Change No. 8  
License No. DPR-27

POINT BEACH NUCLEAR PLANT UNIT 2

SAFETY EVALUATION FOR REDUCED PRIMARY SYSTEM PRESSURE OPERATION

CHANGE NO. 8 TO  
TECHNICAL SPECIFICATIONS FOR  
FACILITY OPERATING LICENSE NO. DPR-27  
FOR POINT BEACH NUCLEAR PLANT UNIT 2  
WISCONSIN ELECTRIC POWER COMPANY  
WISCONSIN MICHIGAN POWER COMPANY  
DOCKET NO. 50-301

Figure 15.2.1-1 Core DNB Safety Limits

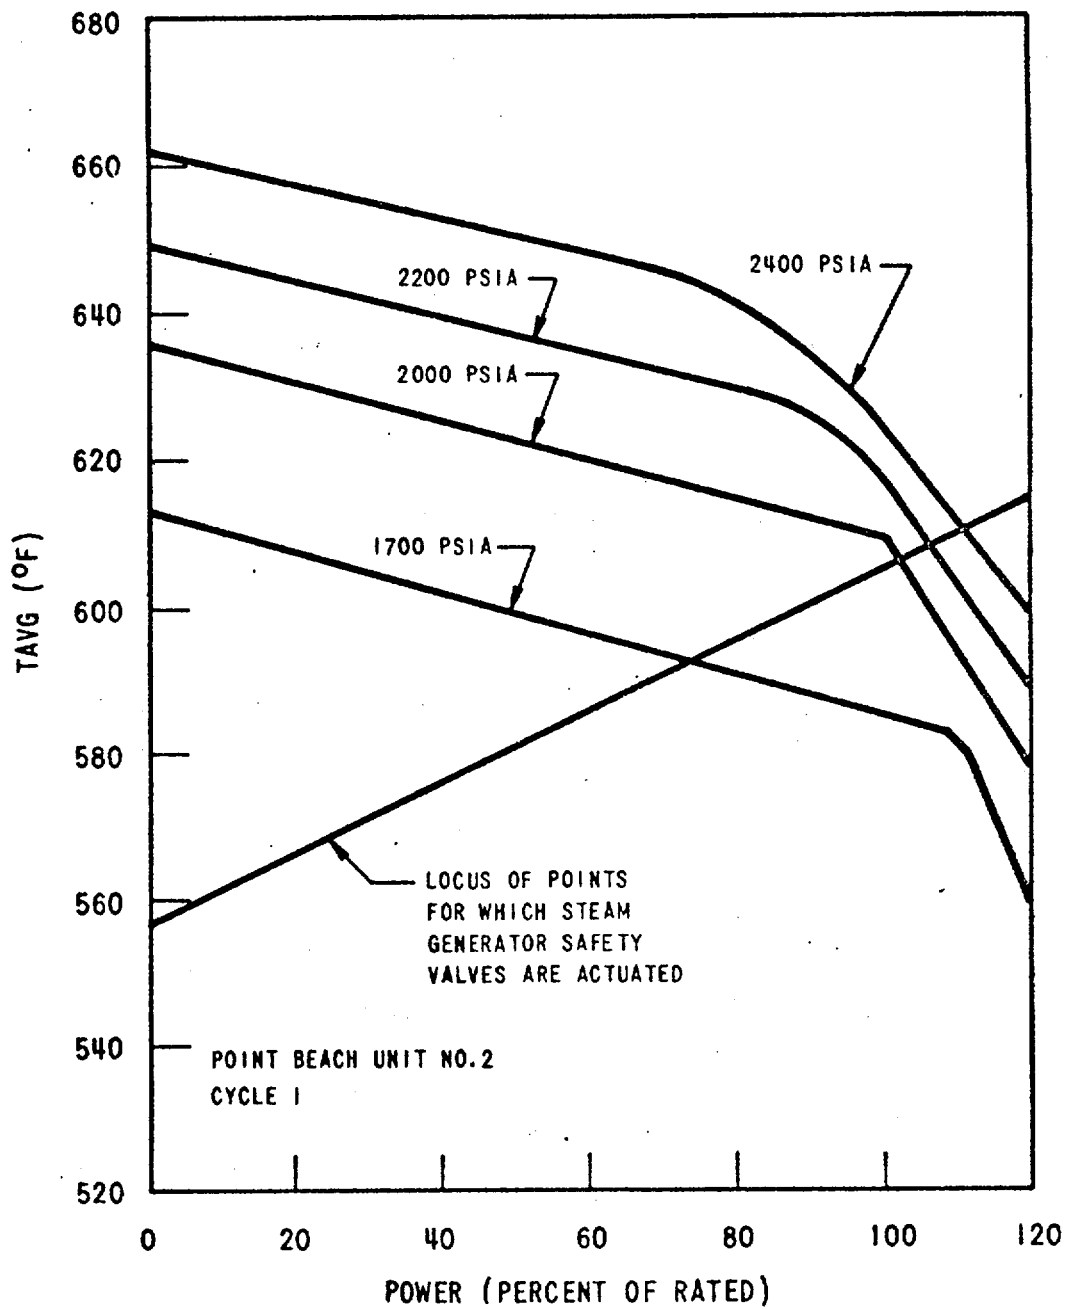
Changes to the Limiting Safety System Settings will be made in Section 2.1 to limit fuel residence time to 13,000 EFPH; to Section 2.3.1-B to reduce the low pressurizer pressure trip setting, and to revise the Overtemperature  $\Delta T$  trip setting, and to revise the Overpower  $\Delta T$  trip setting; all in accordance with revised Figure 15.2.1-1.

anticipated transients. We find this acceptable and conclude that the DNB margins are similar to those at 2250 psia pressure because the reactor coolant temperatures have been reduced accordingly. The revised Core DNB Safety Limits are presented in Figure 15.2.1-1 of WCAP 8151.

Figure 15.2.1-1 also includes an allowance for an increase in the enthalpy rise hot channel factor at reduced power based on the expression:

The overpower, overtemperature and pressurizer pressure system setpoints have been revised to include effect of reduced system pressure operation (including the effects of fuel densification). The revised setpoints as given above will not exceed the revised core safety limits as shown in Figure 15.2.1-1.

1. The combination of thermal power level, coolant pressure, and coolant temperature shall not exceed the limits shown in Figure 15.2.1-1. The safety limit is exceeded if the point defined by the combination of reactor coolant system average temperature and power level is at any time above the appropriate pressure line.
2. The fuel residence time for Unit 2, Cycle 1, shall be presently limited to 13,000 effective full power hours (EFPH) under design operating conditions, provided the primary system pressure is reduced to 2000 psia by 6500 EFPH. The Licensee may propose to operate the core in excess of 13,000 EFPH by providing an analysis which includes the effect of clad flattening or a change in operating conditions. Any such analysis, if proposed, shall be approved by the Regulatory staff prior to operation in excess of 13,000 EFPH.
